PLANNING DEPARTMENT

PLANNED UNIT DEVELOPMENT PERMIT NO. 07-000008 (PUD 07-000008)

“Coffee Grounds One”

SUBJECT : **Planned Unit Development Application (PUD 07-000008)**
Applicant: Riehm Owensby Planners Architects
Owner: CGH, LLC
Proposed: PUD-Coffee Grounds One
Location: Kahului, N. Kona, HI
TMK: 3 / 7-5-014: 002, 003, 010, 026, and 029

Figure 1: Master Plan Concept

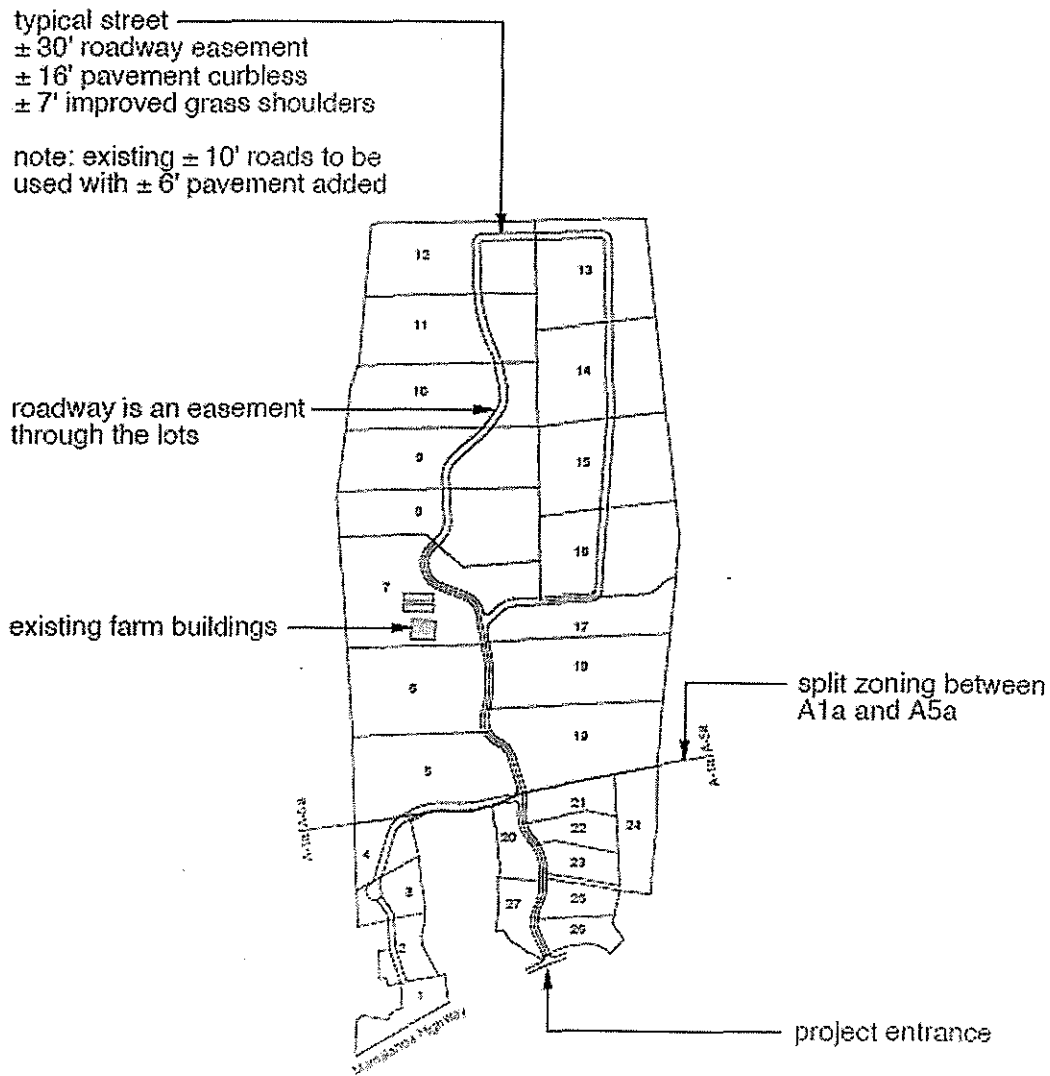
When considering a Planned Unit Development Permit application, we understand the conceptual nature of the proposed subdivision layout at this early stage of review. However, in order for this office to consider the request for variances from the minimum requirements of code, there are known site characteristics that we would have hoped would have been more closely considered during the preliminary design of the proposed subdivision and laying out of its infrastructure, namely the roadways. While we will support this PUD Permit, subdivision of the Property will encounter substantial difficulties that largely deal with its severe grades and therefore, approval of this PUD Permit does not necessarily mean that we are approving the lot layout as shown in Figure 1. While the intent of the Applicant was to utilize existing roadways

(driveways) within the Property, it is clear that these alignments go directly against the severe grades and will not meet the grade limits established by Department of Public Works. For example, there are sections at the 1,800-1,990' elevation that appear to be at a 20% grade, with a 22% grade from 1,800-1,890'. While these steep roads may be fine for the Applicant as it maintains its coffee farm, a subdivision of this Property will result in homeowners having to deal with a severe downhill run along these roadways. It always makes sense to moderate these types of severe grades by winding a roadway down a hill. There are other examples of steeper grades within the Property. Therefore, the Applicant should anticipate the need for realignment of the subdivision roadway for those sections that exceed the maximum 18% grade.

Secondly, with the proposed subdivision to be developed within an area affected by floodways, the layout of the subdivision should not create a lot that has the majority of its buildable area within a floodway or have its access cut off by a floodway. Therefore, will not approve a subdivision of Lot 24 that requires an access pole to traverse the Waiaha floodway unless the Applicant constructs a lot access that will not be cut off in a flood event, such as a culvert crossing that meets the appropriate design requirements of the Department of Public Works.

Exhibit 1: Street Intersection Angles and Radius Variance Request - Subdivision Control Code

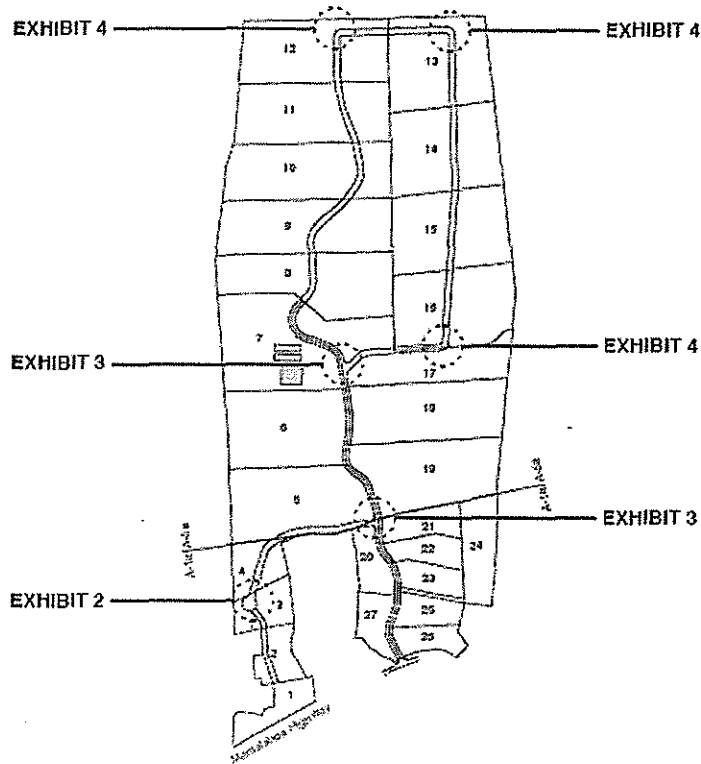
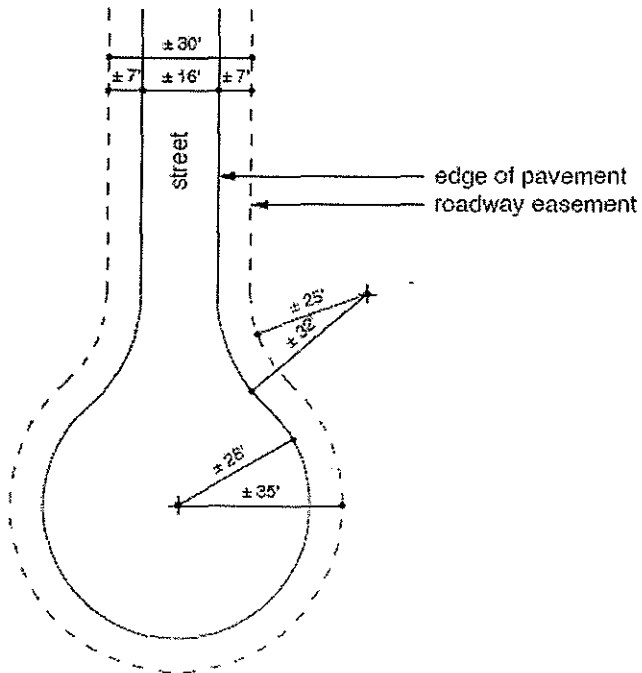
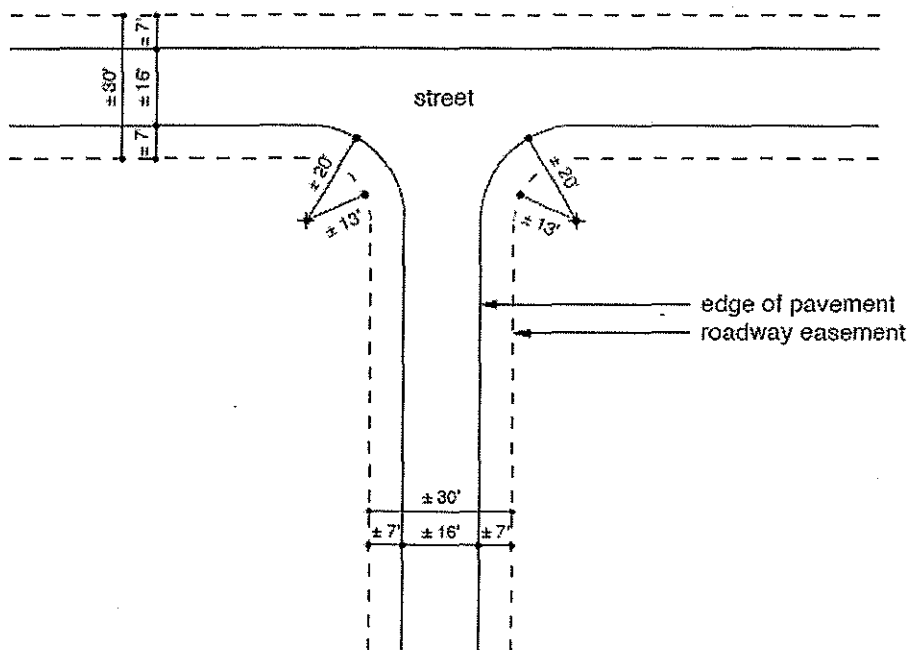
- **Intersection Angles; Corner radius** (Hawaii County Code §23-45). Applicant requests that intersections within the private roadway easements have a maximum radius of 13 feet, subject to sight distance requirements at the pavement line with the actual pavement having a

radius of no less than 20 feet. This variance is approved on the basis that these reduced corner radiuses will occur only at those intersections within the subdivision access road system and not the intersection with the Mamalahoa Highway. A reduction of the intersection angle at the Mamalahoa Highway is permitted, but no less than 60 degrees.

Exhibit 4: Street Intersection Angles and Radius Variance Request - Subdivision Control Code

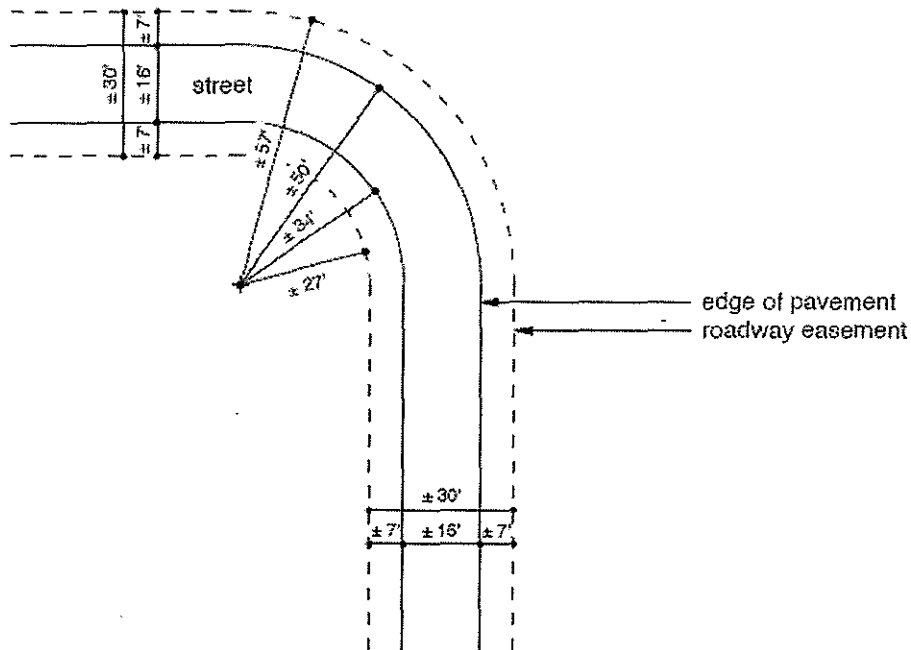
3. Variance request No. 8 from HCC Section 23-45 The approach to Mamalahoa should be excluded from any variance to this section. We do not agree to an approach angle less than 60 degrees or a reduction to the required property line radius at the approach to Mamalahoa Highway. The property line and pavements radii shall meet a higher standard (See ROADWAYS Item 1). Exhibit 4 is

misapplied to Section 23-45. Section 23-45 regulates the minimum corner radius for property lines at intersecting roadways, not horizontal roadway curves.

Exhibit 5: Street Lights

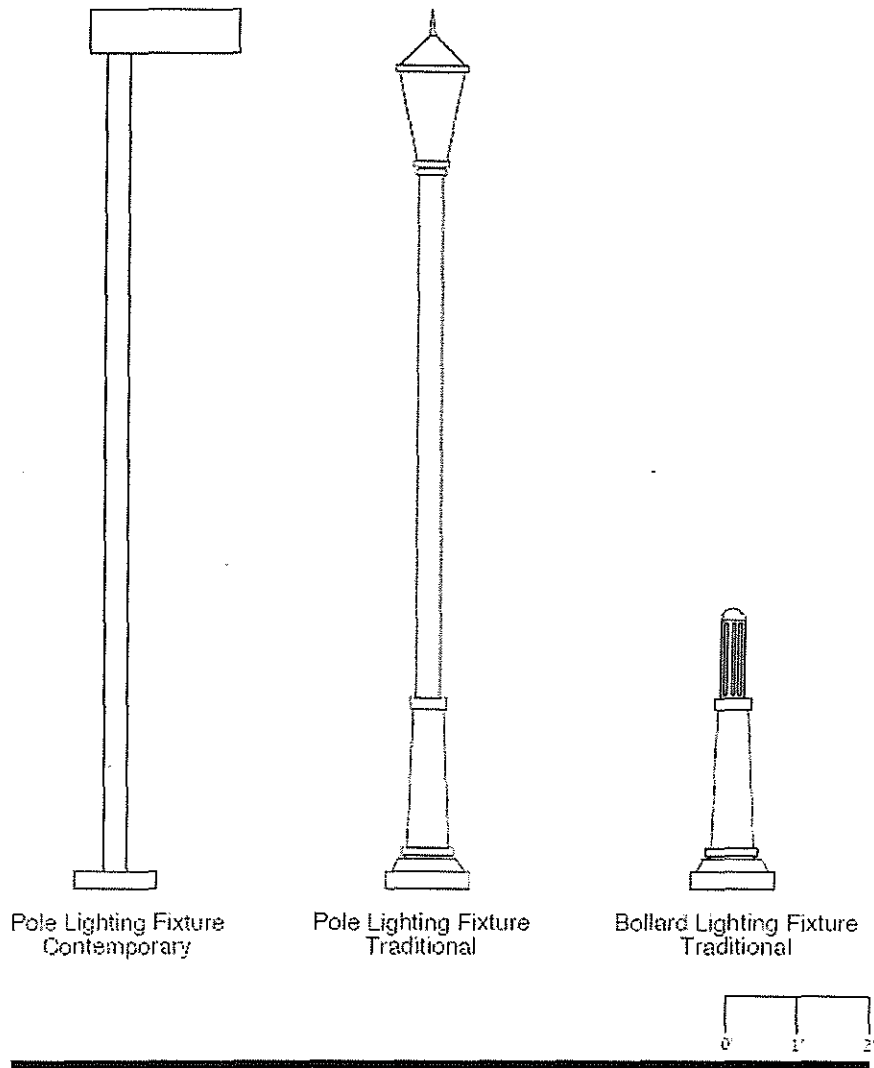
- 1) Is this development county maintained?
- 2) It would not be feasible for the county to maintain custom streetlights to the standards that the developer is proposing – replacements, would need to be provided in advance by the developer or the county standard streetlight fixtures would have to be used instead.
- 3) Lighting would need to conform to the applicable ordinances established for the island.
- 4) It would not be feasible for the county to maintain custom signs and sign posts to the standards that the developer is proposing – all replacements would be with county standard signs and sign posts.
- 5) Signs should conform to the Manual on Uniform Traffic Control Devices (MUTCD).”

- **Street lights** (Hawaii County Code §23-93). Applicant requested design flexibility in the placement and type of street lights permitted within the internal subdivision roadway easement. The Applicant proposes the use of custom street lighting fixtures along the minor-type roadway (see Exhibit No. 5). Due to the limited number of lots to be serviced by the internal subdivision roadway, a reduction in the number of lights would help to impart a more rural feel to the neighborhood while having sufficient lighting primarily at critical points for traffic safety considerations. *This variance is approved subject to the condition that a licensed engineer certify the safety of the lighting plan for the minor streets.* Lighting along the subdivision roadway, including the project entry and mail pick-up area, shall comply with the requirements of the County outdoor lighting code.

Exhibit 6: Street Signs Variance Request - Subdivision Control Code

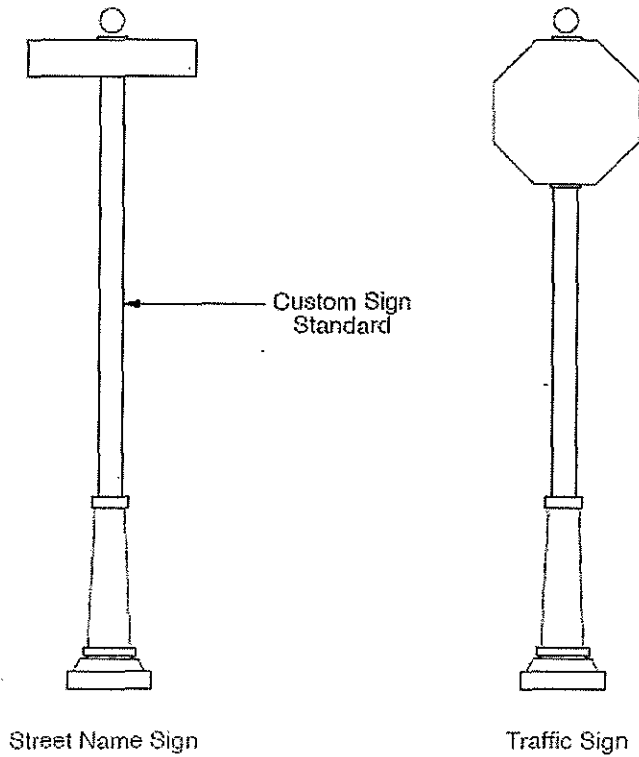
- **Street names & traffic signs** (Hawaii County Code §23-94). Approved to allow use of custom street name and traffic signs that will reinforce the desired character of the neighborhood and its design goals (see Exhibit No 6). While this variance will allow these signs to deviate from standard specifications, it must still meet ASHTO specifications.

Exhibit 7: Right of Way Improvement Variance Request - Subdivision Control Code

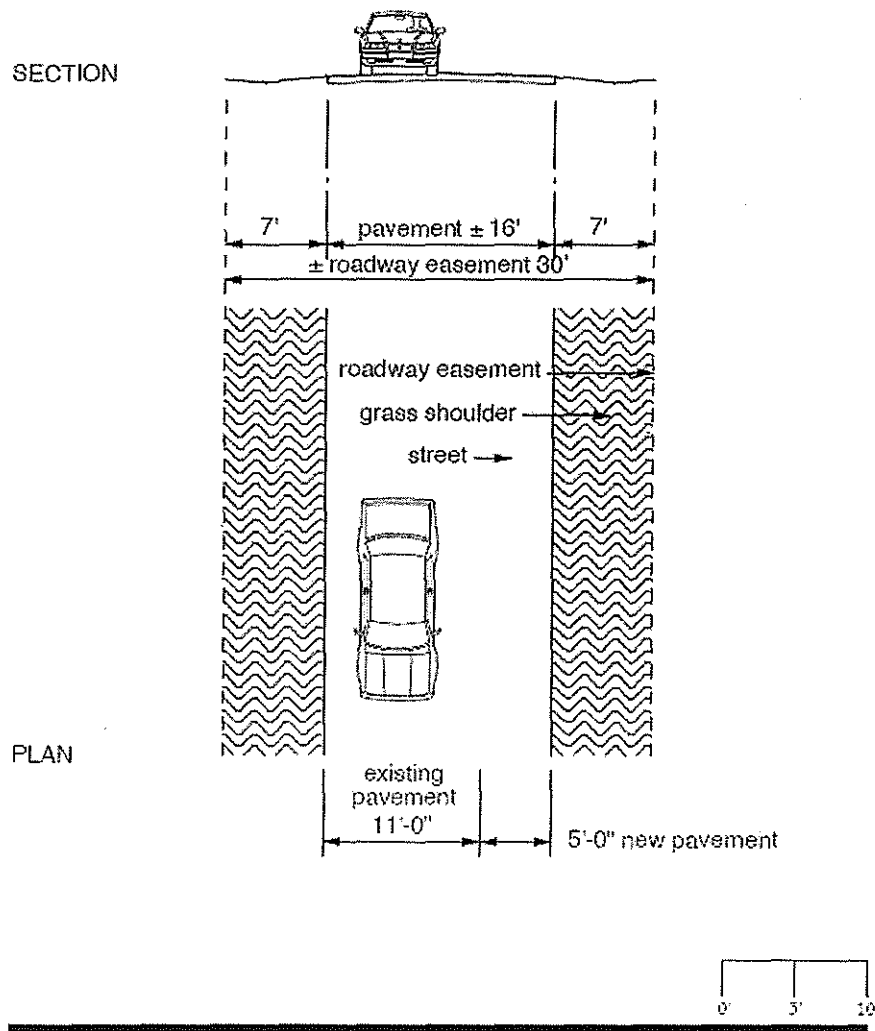
- **Right of way Improvement** (Hawaii County Code §23-95). There is no justification for this variance. Plans submitted by the Applicant indicate that the entire roadway easement will be improved with a paved travelway and grassed shoulders. These improvements, as permitted by this PUD, satisfies this particular requirement.
